Subject: AP1000 Response to Request for Additional Information (TR 09)

RAI-TR09-008 R4

Response to Request for Additional Information on Technical Report No. 09

RAI Response Number: RAI-TR09-008

Figure 6.2.1.1-11 AP1000 External Pressure Analysis Containment Pressure vs. Time

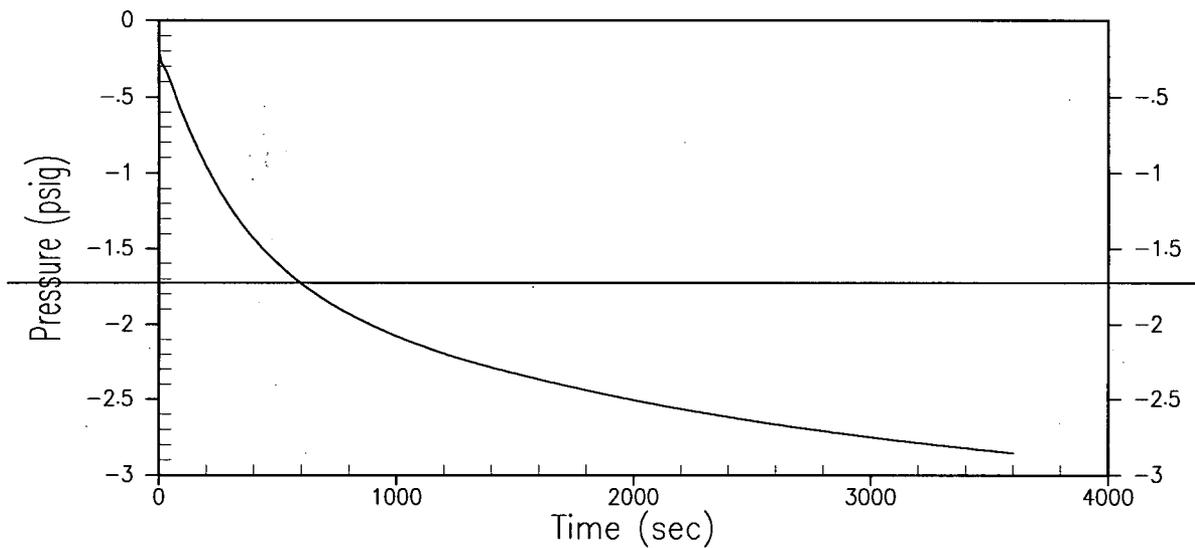
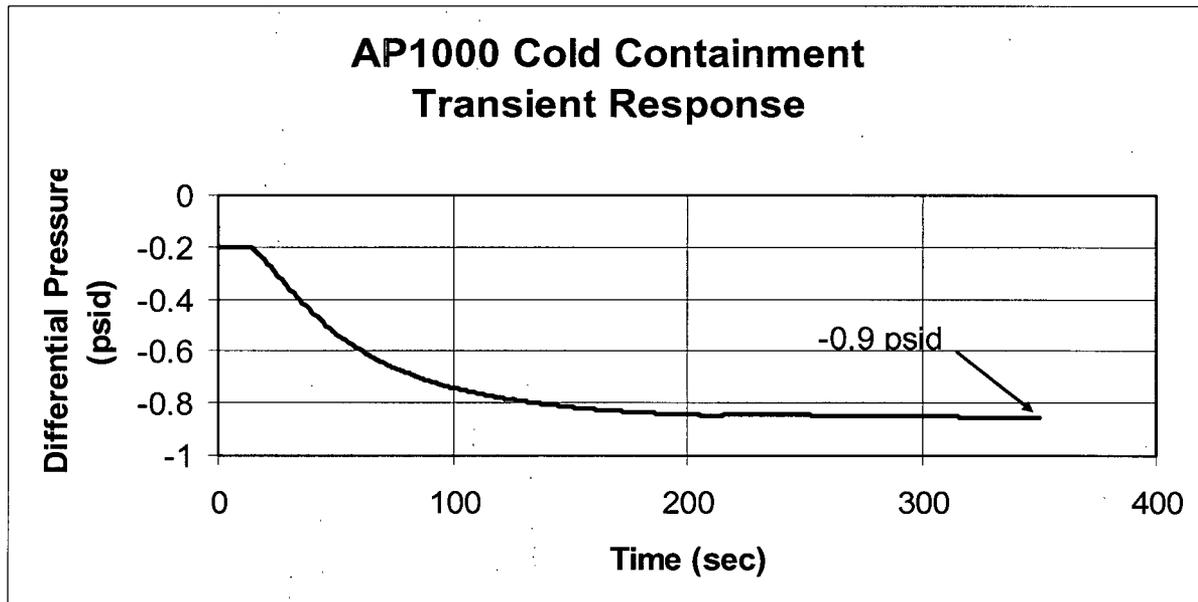
For consistency with Figure 6.2.1.1-11, the words ‘at one hour’ were deleted from the text in section 6.2.1.1.4 of the DCD, Revision 16. This change and all other DCD changes shown below were incorporated in Revision 5 of APP-GW-GLR-134 (Technical Report 134).

The following revisions to Subsection 6.2.1.1.4 and Figure 6.2.1.1-11 were provided in Revision 2 of this response. Please see the response to RAI-SRP6.2.1.1-SPCV-07 Revision 1 and 2 for more recent revisions to this subsection. RAI-SRP6.2.1.1-SPCV-07 Revision 2 modifies Subsection 6.2.1.1.4 to be similar to the description in DCD Revision 15.

Evaluations are performed using WGOTHIC with conservatively low estimates of the containment heat loads and conservatively high heat removal through the containment vessel consistent with the limiting assumptions stated above. Results of these evaluations demonstrate that ~~at one hour~~ after the event the net external pressure is approximately -0.9 psid which is within the capability of the containment vessel. The pressure changes very slowly after the initial decrease and there is ~~within the 2.9 psid design external pressure~~. This ~~is~~ sufficient time for operator action to prevent the containment pressure from dropping below the -0.9 psid external pressure, based on the PAM's containment pressure indications (four containment pressure instruments) and the ability to mitigate the pressure reduction by opening either set of containment ventilation purge isolation valves, which are powered by the 1E batteries.
